DOCUMENT CHANGE REQUEST

DCR number 164	Changes required for: General	Originator: Steve Thacker
Date: 2005/11/02	Date sent: 2005/11/02	Organisation: ESA/ESTEC
Status: IMPLEMENTED

Title:	Attenuator, RF Coaxial, Type SMA, DC-22GHz		
Number:	3403/005	Issue:	1

ESCC Detail Specification No. 3403/005

1.6 PHYSICAL DIMENSIONS

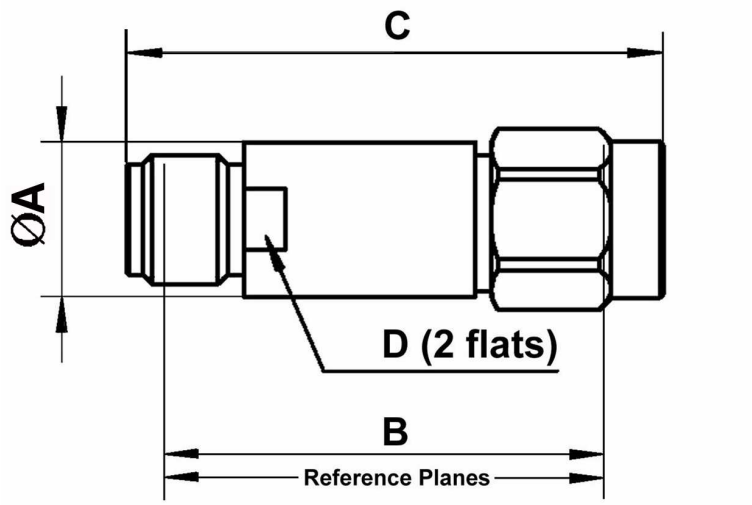
10. Figure 2 Physical dimensions: drawing amended to only include critical dimensions (Dim's D E F G are deleted). Reference to 3402/003 deleted and interface dimension drawings added (male & female).

2.3 CONTACT ENGAGEMENT AND SEPARATION FORCES TEST

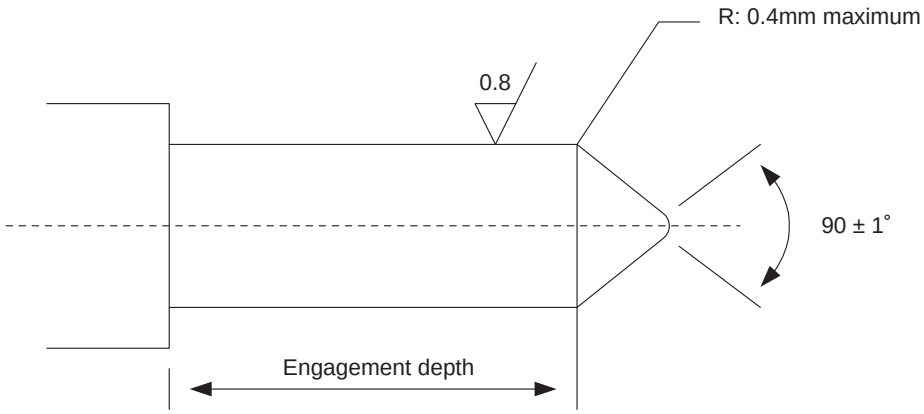
13. Para 4.3.5 Contact Engagement and Separation Forces: Details from 3402/003 included in this para.
